REMARKS

Appl. No. 10/601,532
Amdt. Dated July 26, 2005
Reply to Office Action of January 26, 2005

DRAWING AMENDMENTS

FIG 1

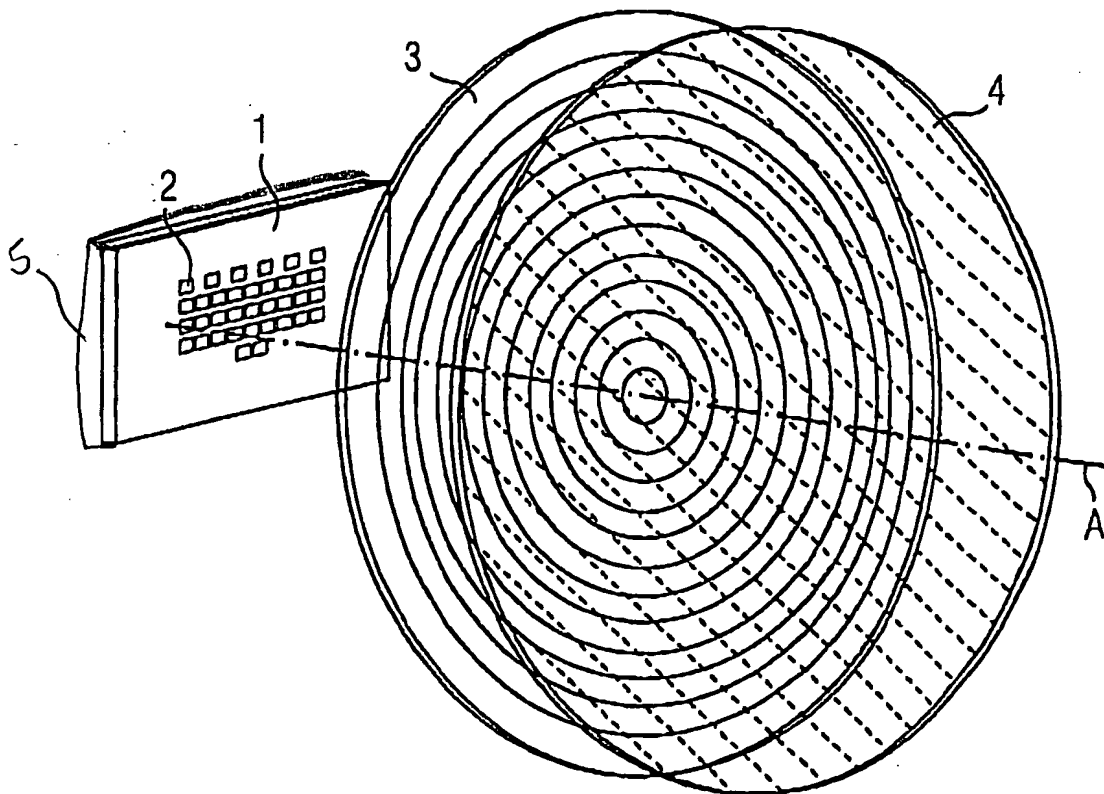
Under the heading "Drawings" on page 2 of the Office Action, the Examiner objected to the drawings for not showing the heat sink recited in claims 13 and 31. Fig. 1 has been amended to show the heat sink 5. The specification has been amended to recite the reference numeral 5 for the heat sink on page 11 of specification.

The attached sheet of drawings includes changes to Fig. 1. This sheet which includes Figs. 1-2, replaces the original sheet including Figs. 1-2. In Fig. 1, a heat sink 5 was added.

Please approve the drawing changes that are marked in red on the accompanying "Annotated Sheet Showing Changes" of Fig. 1. A formal "Replacement Sheet" of amended Fig. 1 is also enclosed.
